Report: TAB Report
Function: Test, Adjust, & Balance
Date: 01/21/2026
Completed By: National TAB

01-12-26 Wawa #7402 Indianapolis, IN

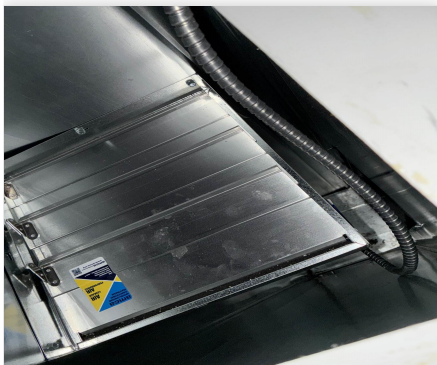
Issue Name : EF-1 BACKDRAFT
Description : EF-1 backdraft damper too small for ductwork. This impedes TAB as it reduces total airflow. Potentially related to over-amp issue.
Created By : National TAB **Assigned To :** National TAB - Noah Stafford
Status : Open
Priority : Urgent **Asset Tag :**
Originated Date : 01/12/2026 - Noah Stafford - National TAB

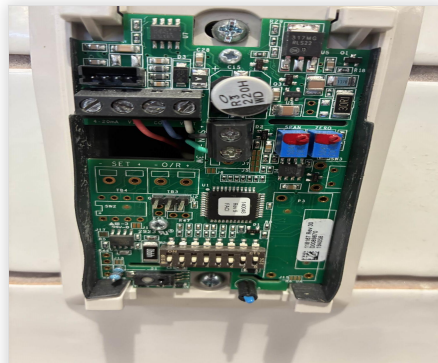
Issue Name : EF-1 OVER AMPERAGE
Description : EF-1 operating at 4.0A, exceeding motor rating of 3.8A. Speed cannot be safely increased to meet design airflow. Potentially related to backdraft issue.
Created By : National TAB **Assigned To :** National TAB - Noah Stafford
Status : Open
Priority : Urgent **Asset Tag :**
Originated Date : 01/23/2026 - Noah Stafford - National TAB

- **02/24/2026 National TAB - Nathan Denney**
 - Unit operating at lowest setting and is at 3.7/3.8A. Cannot increase total flow without over amping fan.

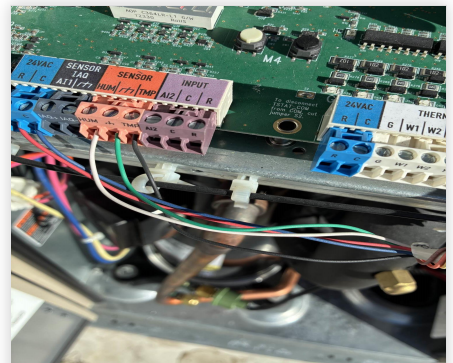
Issue Name : RTU SENSOR WIRING
Description : RTUs use only thermostat wiring for the sensors. Design plans call for twisted pair shielded cables containing 18AWG minimum. This issue does not prevent TAB.
Created By : National TAB **Assigned To :** National TAB - Noah Stafford
Status : Open
Priority : Medium **Asset Tag :**
Originated Date : 01/12/2026 - Noah Stafford - National TAB
